CITY OF GLENDALE, CA

DESIGN REVIEW STAFF REPORT – SINGLE FAMILY

1434 E. Maple Street
Address

PADR-000877-2023
Case Number

PROPOSED SITE PLAN 2
 1/8"=1'-0"

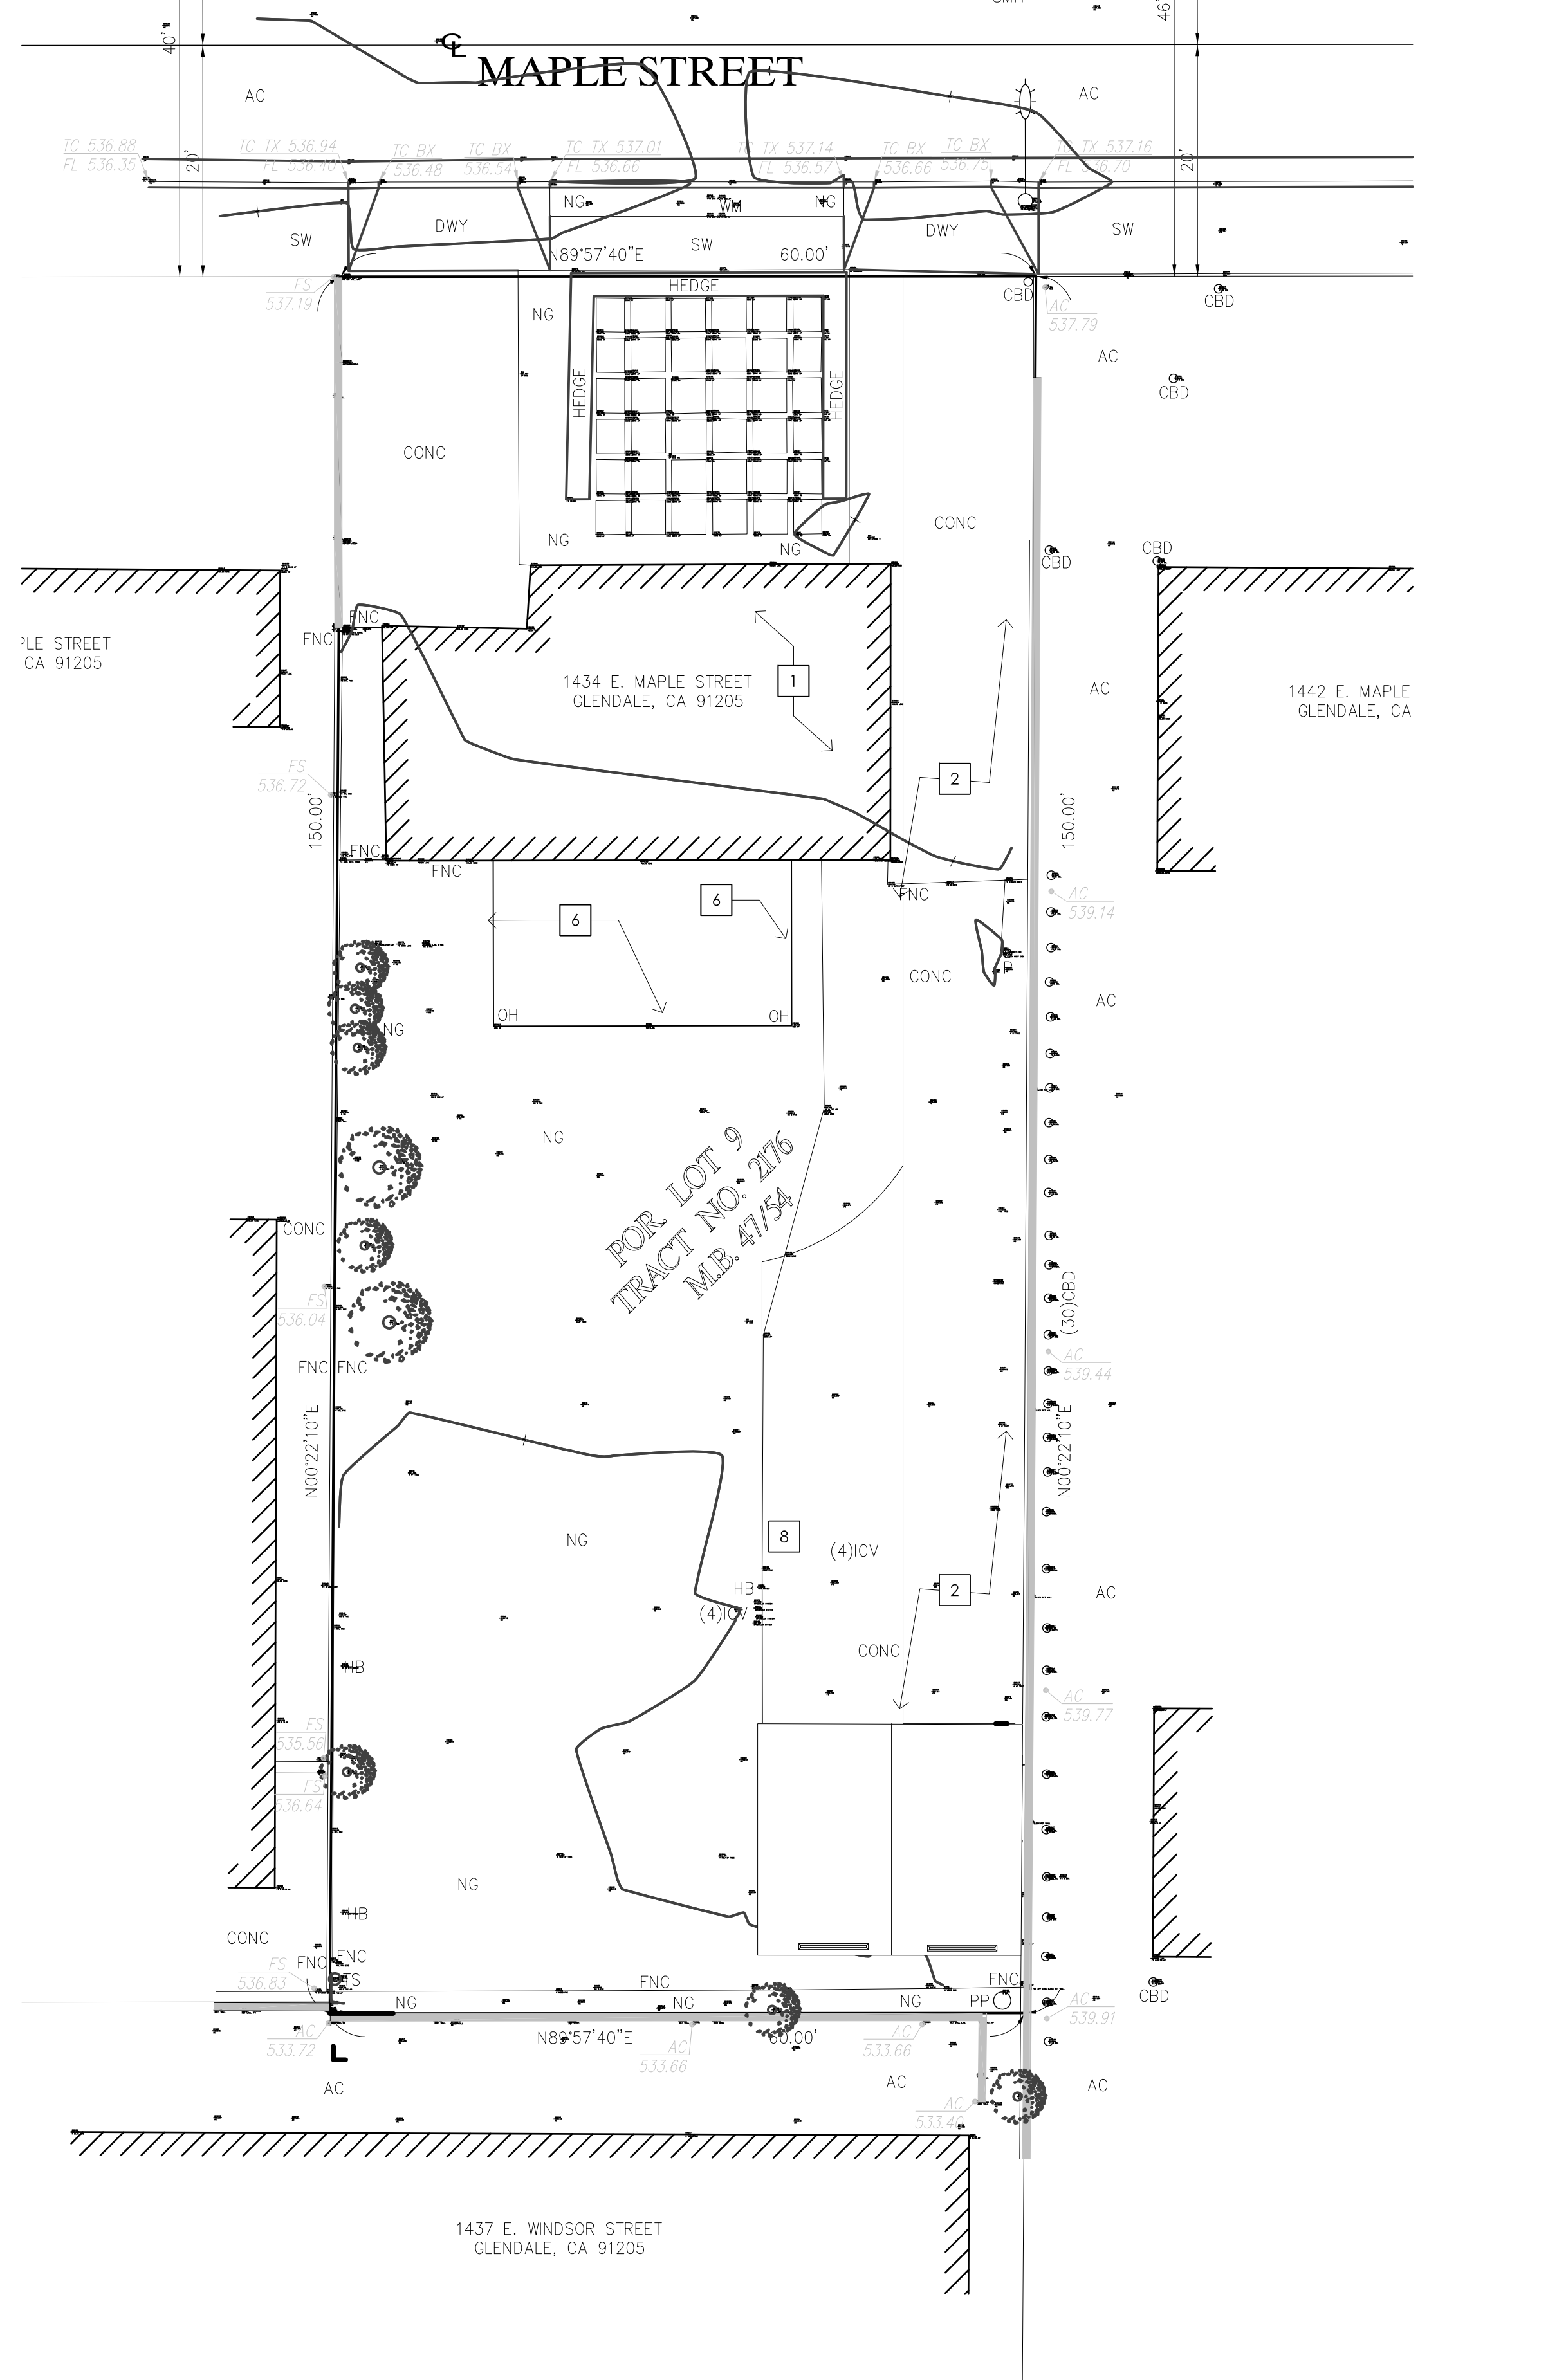
Access to the new the garage is provided from an existing concrete driveway that is accessed from E. Maple Street. As a consideration, the concrete driveway should incorporate decorative paving elements (such as brick, stone, stamped concrete) to enhance the appearance viewed from the street.

ROOF PLAN 1
1/4"=1'-0"

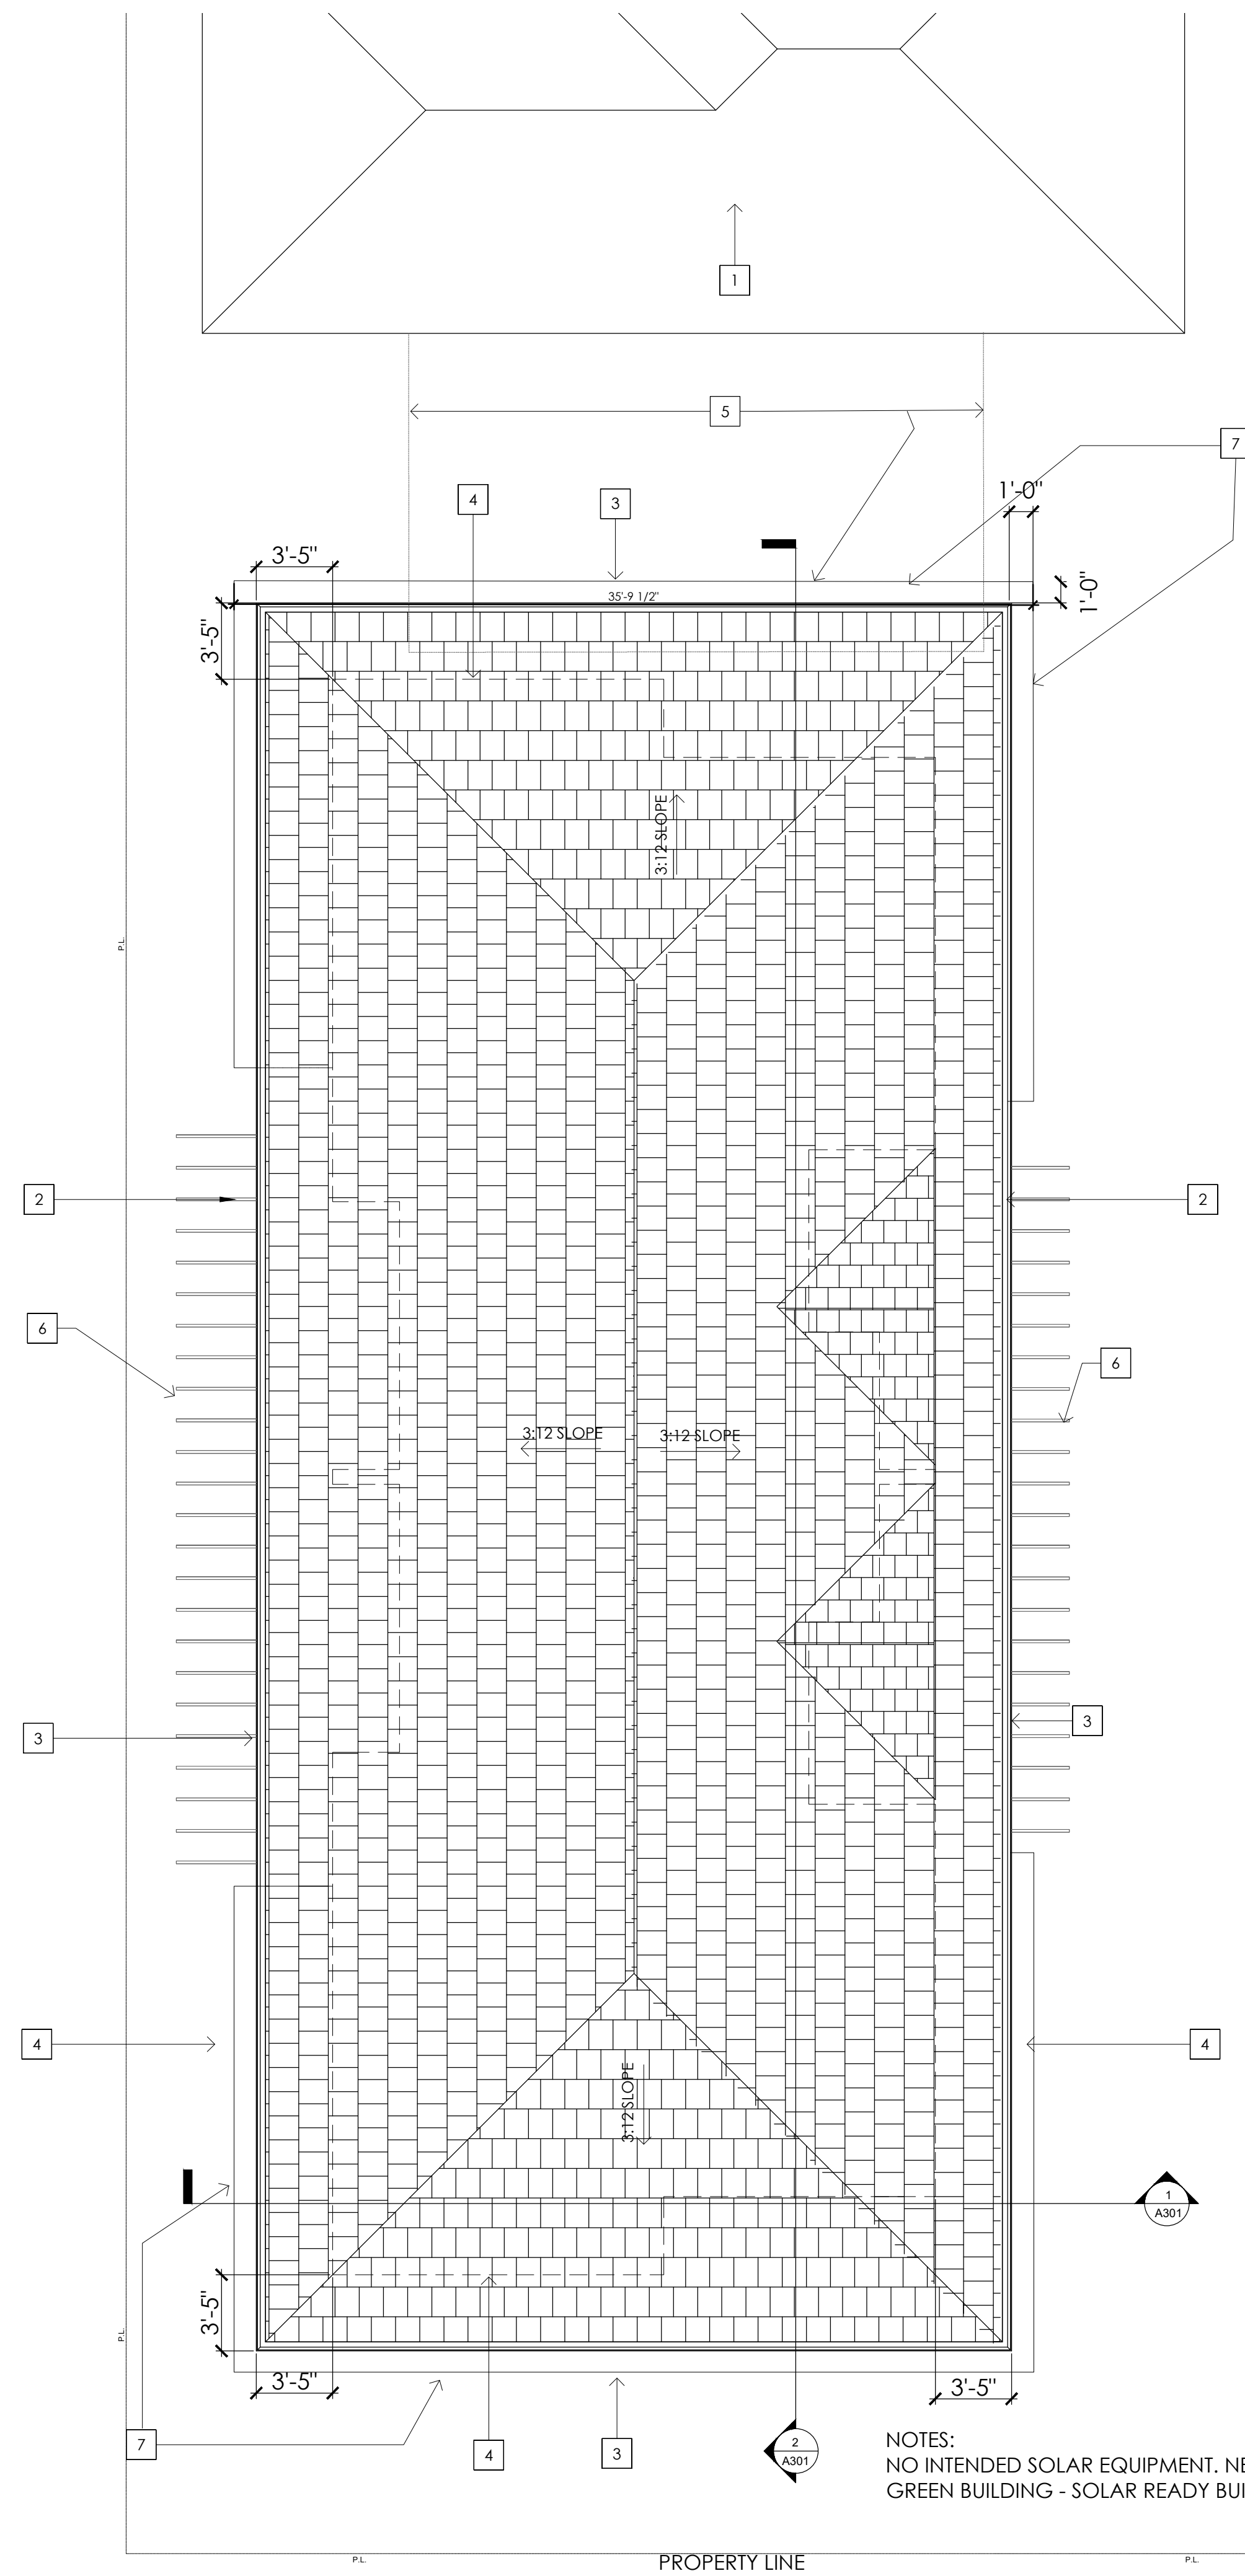
For better design integration, a condition is included to revise the roof plan to ensure that all roof eaves have the same depth and consider adding layers to the roof form to be more consistent with the primary dwelling, removing the tacked-on gables above the patios if necessary. And bring the roof on the first-story all the way to the second-story balconies for a more natural flow.

- The new building is designed with a hipped roof form. For better design integration with the existing house, a condition is included to revise the roof form and provide a better overall design that more naturally match the primary dwelling.

1. Revise the roof plan to ensure that all roof eaves have the same depth and consider adding layers to the roof form to be more consistent with the primary dwelling, removing the tacked-on gables above the patios if necessary. And bring the roof on the first-story all the way to the second-story balconies for a more natural flow.
2. That specifications (cut sheets) for the exterior lighting fixtures on the new building and locations shall be submitted to staff for review and approval prior to plan check submittal. The exterior lighting should be appropriate to and consistent with the style of the new building; limit their location to the main entry and patio doors.
3. Paint the gutters to match the adjacent wall color.
4. That all new fences/wall/gates be clearly shown on the plans for staff review and approval prior to plan check submittal.
